Project	IEEE 802.16 Broadband Wireless Access Working Group < http://ieee802.org/16 >	
Title	Forcing all MSs to be reset at once	
Date Submitted	2005-07-14	
Source(s)	Yeongmoon Son, Jungje Son, Panyuh Joo Samsung Electronics Co. Ltd.	Voice: +82-31-279-5845 FAX: : +82-31-279-5130 ym1004.son@samsung.com
Re:	IEEE P802.16e/D9	
Abstract	This contribution proposes the scheme for forcing all MSs to be reset at once	
Purpose	Discuss and adopt this contribution	
Notice	This document has been prepared to assist IEEE 802.16. It is offered as a basis for discussion and is not binding on the contributing individual(s) or organization(s). The material in this document is subject to change in form and content after further study. The contributor(s) reserve(s) the right to add, amend or withdraw material contained herein.	
Release	The contributor grants a free, irrevocable license to the IEEE to incorporate material contained in this contribution, and any modifications thereof, in the creation of an IEEE Standards publication; to copyright in the IEEE's name any IEEE Standards publication even though it may include portions of this contribution; and at the IEEE's sole discretion to permit others t

Figure 1 – The Operation by Restart Count TLV encoding in DCD message

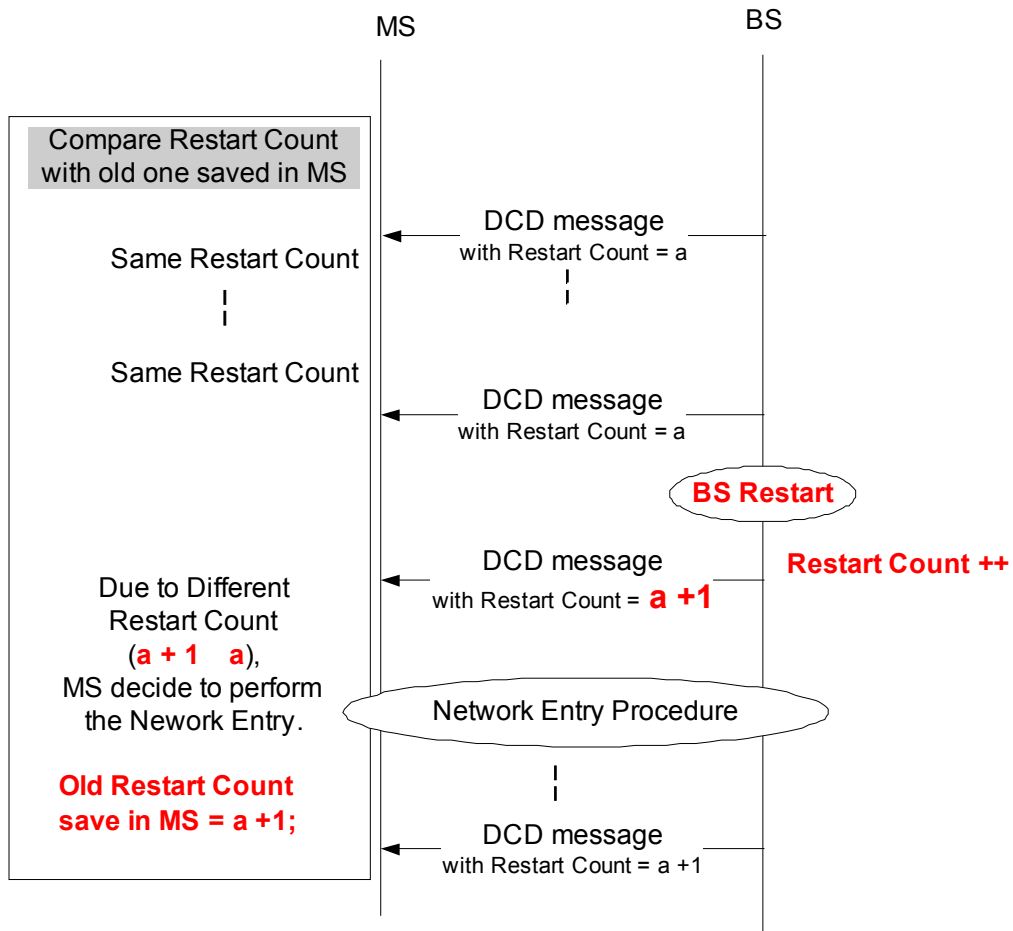
BS may intentionally increment the restart count to be included in DCD message for the purpose of forcing all MSs to perform the Network Entry due to BS's some problem.

Because the restart count is periodically broadcasted, the restart count scheme is available regardless of MS's state (i.e. normal state, sleep, idle mode)

Figure 1 shows the operation by BS Restart Count TLV encoding in DCD message
